Our ref: L.A10908.002.00.Addendum02.docx

**RE: FLOOD ASSESSMENT FOR OAKDALE EAST INDUSTRIAL ESTATE MASTERPLAN AND
STAGE 2 WORKS – ADDENDUM NO. 2**

This letter forms Addendum No. 2 to the 'Flood Assessment for Oakdale East Industrial Estate Masterplan and Stage 2 Works' (BMT, 2022). It outlines the updated flood modelling and assessment completed for AT&L's updated design that incorporates a retaining wall along the eastern extent of the Precinct 5 fill platform to reduce the encroachment of the Precinct 5 embankment into the flood extent of Reedy Creek.

Figure 1.1 Location of Quarry Pit Infill Area Adjacent to Precinct 5

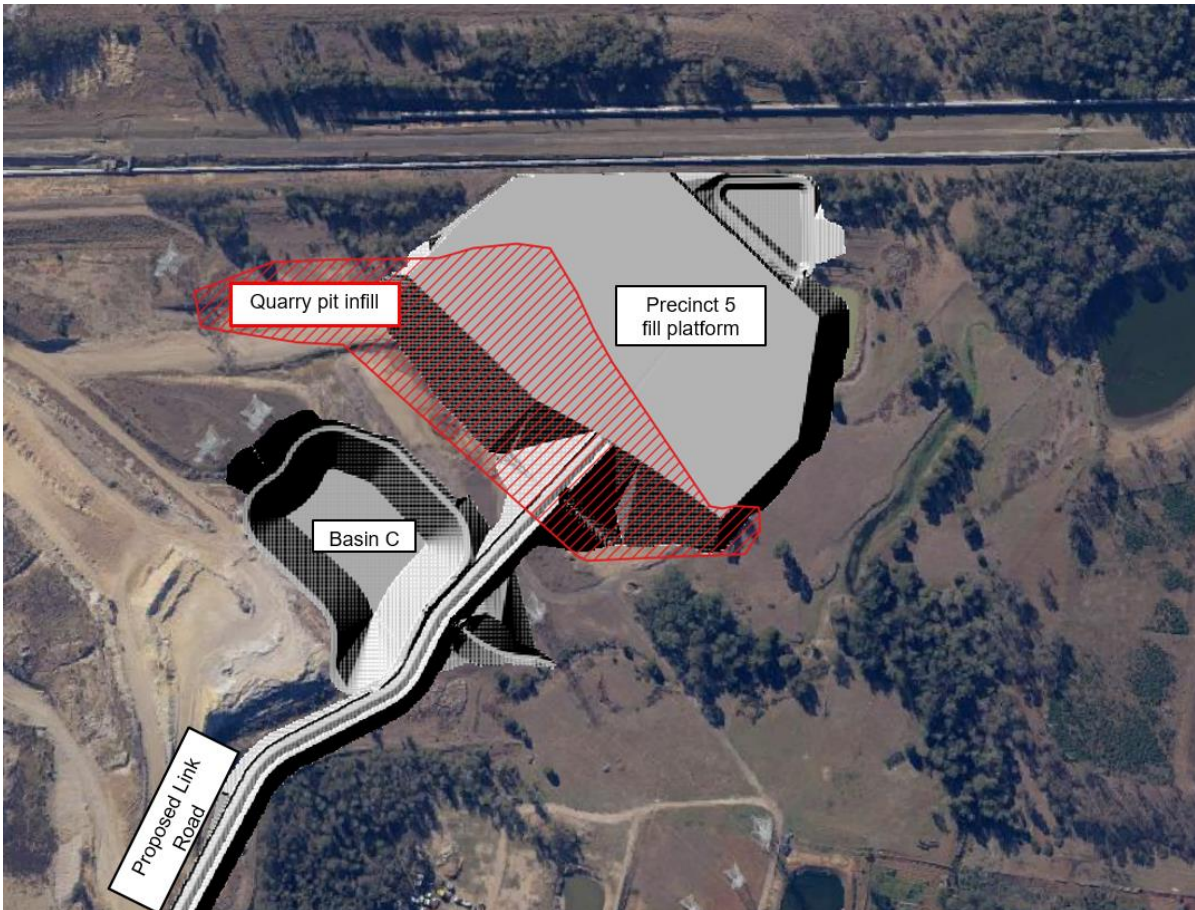
Before commencing this latest modelling work, a review of the TUFLOW modelling assumptions from the for the Oakdale East Flood Assessment (2022) was completed to ensure the model's suitability for this updated flood assessment. The focus of this review was on the low-lying quarry pit between proposed Basin C and Precinct 5, as shown in Figure 1.1. This area was modelled as follows for the Oakdale East Flood Assessment (2022):

- Baseline Scenario: The quarry pit was modelled as a water storage incorporating an Initial Water Level (IWL) equivalent to the lowest point around the top perimeter of the pit, with the waterbody assumed to be 100% impervious for the purposes of applying initial and continuing losses in the rainfall-on-grid TUFLOW model.
- Developed Scenario: Based on email correspondence from Mr Anthony McLandsborough of AT&L to BMT dated 4 May 2022, the low-lying land between Basin C and Precinct 5 and to the west of Access Road was infilled, with overland flow from this area draining eastwards to Reedy Creek via a culvert crossing beneath the roadway (to be incorporated in future design).

However, Mr Anthony Landsborough of AT&L advised on 29 June 2023 that the quarry pit in Precinct 5 will be infilled as part of remediation works to be completed onsite by others prior to the construction of Precinct 5 works considered in this SSDA. Therefore, the following modifications were made to the Baseline Scenario TUFLOW model as part of the updated flood assessment documented herein:

- Infill of Precinct 5 quarry pit to tie in with ground surface elevations around the perimeter of the quarry pit to reinstate pre-quarry conditions.
- Adjusting surface material and roughness of the quarry pit infill area from waterbody to earth infill to ensure the initial/continuing losses and Manning's n values are consistent with conditions following quarry rehabilitation.

The modelling assumptions and Baseline Scenario TUFLOW model updates listed above were also carried over to the updated Developed Scenario TUFLOW model (i.e. rather than the previous 2022 flood assessment infilling of low-lying land between Basin C and Precinct).

These model modifications ensure that this updated flood assessment only considers flood impacts resulting from the proposed Oakdale East Industrial Estate Masterplan and Stage 2 works, rather than from quarry rehabilitation works.

Figure 1.2 Proposed Retaining Wall Alignment Along Precinct 5 Fill Platform

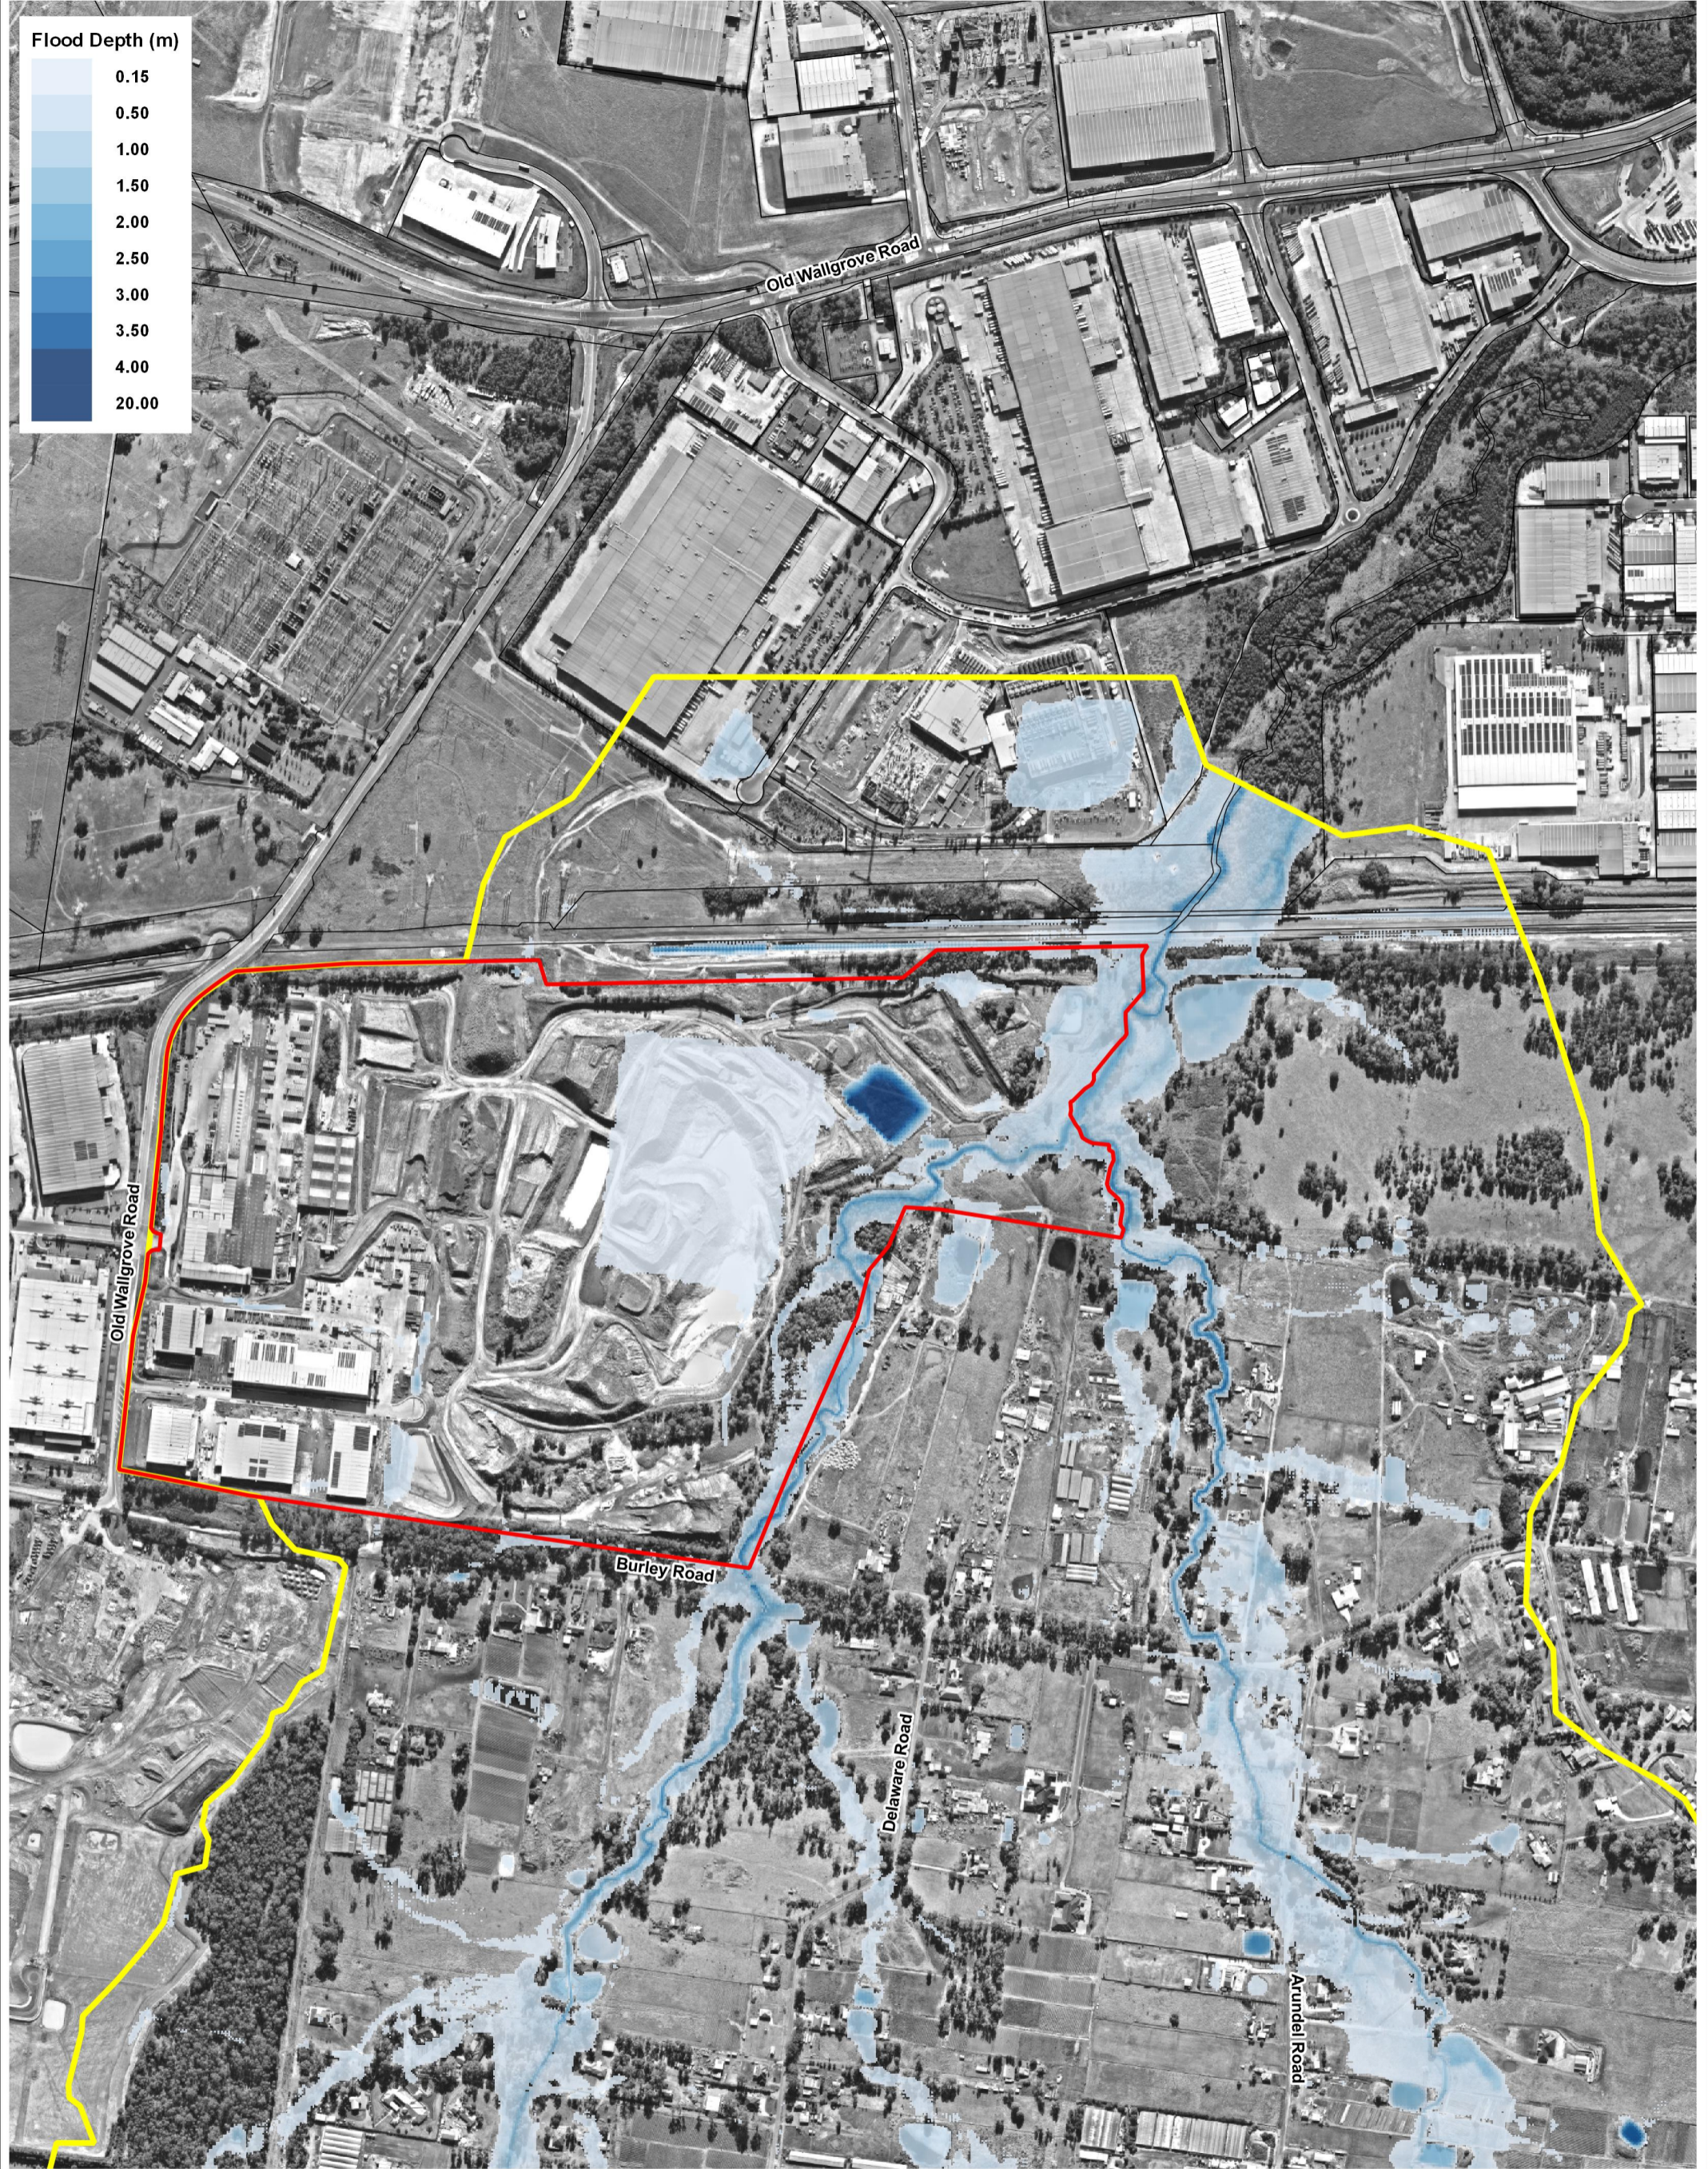
Therefore, the response provided is not satisfactory as extent of afflux in flooding located in neighbouring property is too high. The development should have negligible impact on neighbouring properties. Council defines this as no more than 0.01m afflux for the 1% AEP event.”

In order to mitigate flood impacts on neighbouring properties and seek to comply with Council’s afflux requirements, an updated design for Precinct 5 was prepared by AT&L and provided to BMT on 22 June 2023. This updated design incorporates a retaining wall (rather than batter slope) along the eastern boundary of the Precinct 5 fill platform, thereby reducing the potential encroachment of fill into the Reedy Creek flood extent. Accordingly, BMT were engaged by Goodman to update the flood and impact modelling to assess the flood behaviour and impacts associated with this latest design, as outlined in the following sections.

The Developed Scenario TUFLOW model was also updated to incorporate the updated design prepared by AT&L, which incorporates a retaining wall (rather than batter slope) along the eastern boundary of the Precinct 5 fill platform. This is shown in Figure 1.2.

Title:
Change in Peak Flood Level - 1% AEP Flood

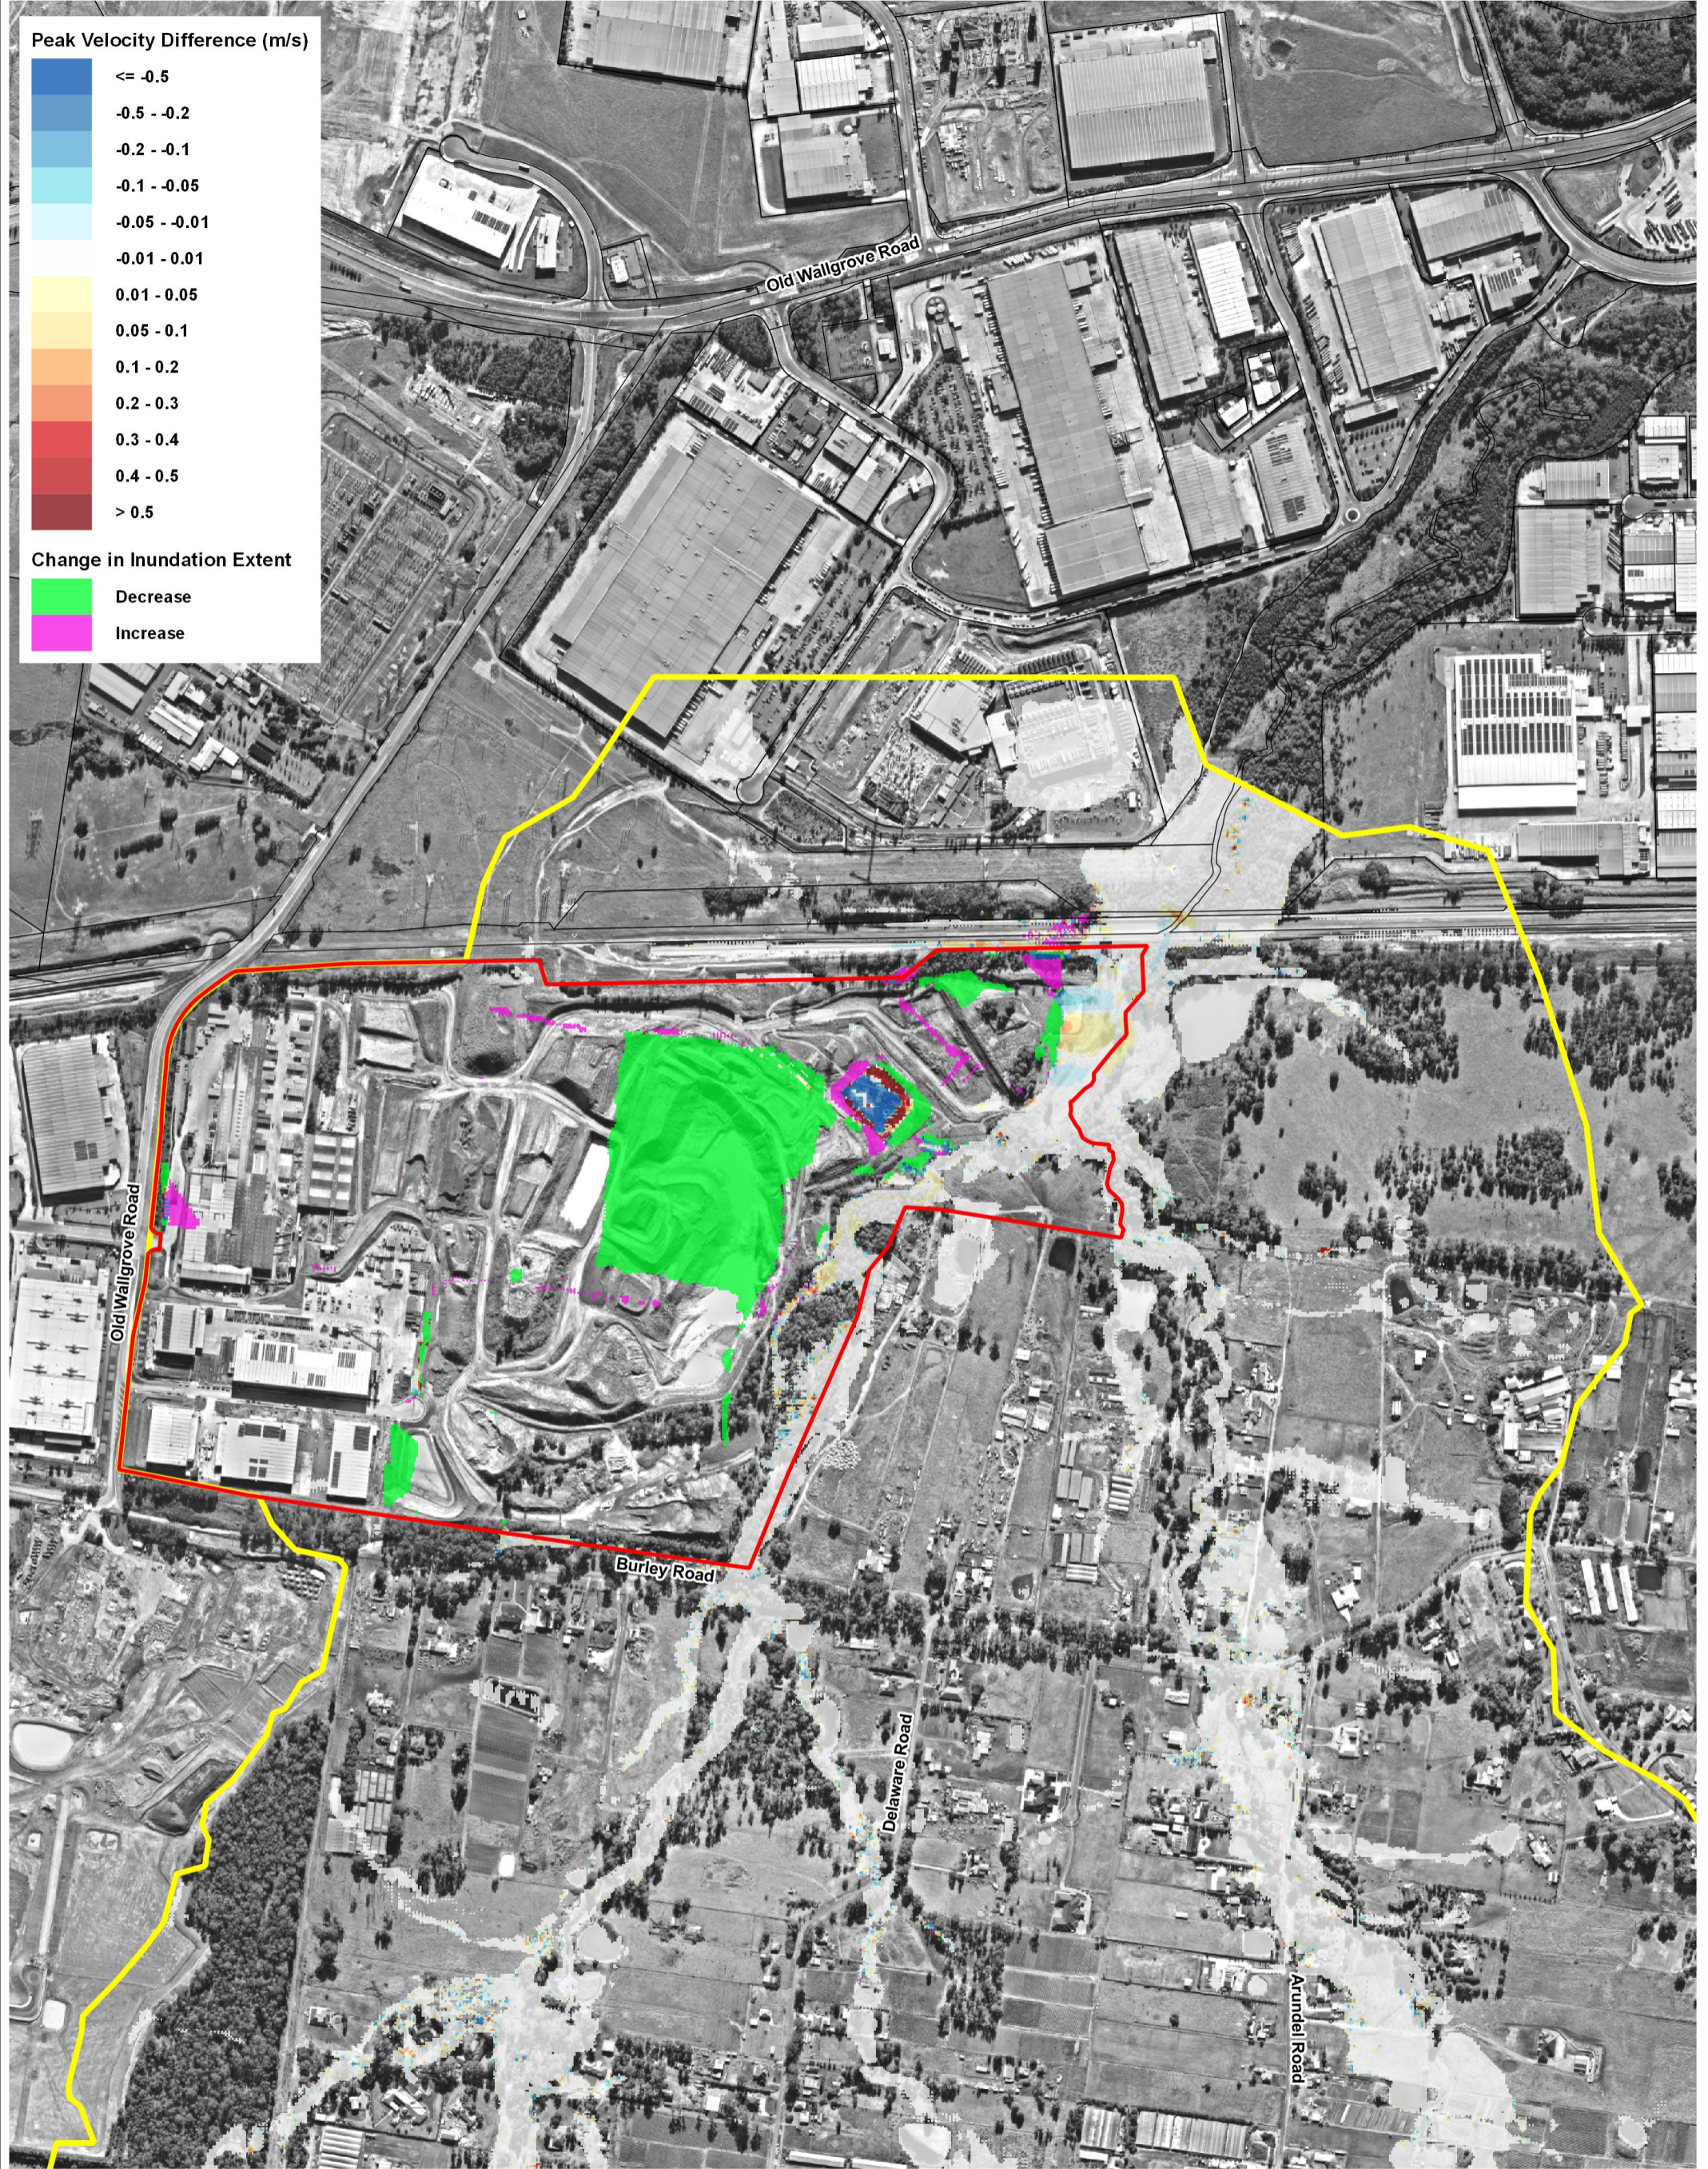
The updated flood report, Flood Addendum No 1 dated 21 March 2023 is focussed specifically on the impact to the Water NSW pipeline. It does not provide any additional afflux mapping, in particular to the privately owned property to the east.

The change in peak flood level, velocity and velocity-depth maps provide a visual representation of the differences between the Baseline and Developed Scenarios. The difference maps were created by subtracting results for the Baseline Scenario from the results for the Developed Scenario and show the location and magnitude of changes in flood level, velocity and VxD associated with the proposed development. Note that filtering of results has been undertaken by removing areas with depths below 150 mm, in line with Council's 'Fairfield Rural Area Flood Study (Ropes, Reedy & Eastern Creeks)' (BMT, 2013). Flood level impacts have been mapped at 0.01 m intervals, as per Fairfield City Council's requirements for Developer Agreement assessments.

The maps indicate a reduction in afflux within Reedy Creek and across neighbouring private properties when compared to the results presented in the Oakdale East Flood Assessment (2022).

It also includes updated flood mapping in Annex A that supersedes flood mapping previously provided in the Oakdale East Flood Assessment (2022). The results documented herein indicate that the updated design is predicted to result in a reduction in peak 1% AEP flood level impacts across neighbouring properties relative to those impacts presented in the Oakdale East Flood Assessment (2022). Peak 1% AEP flood level impacts across private property to the east of the site is predicted to be less than 0.01 m.
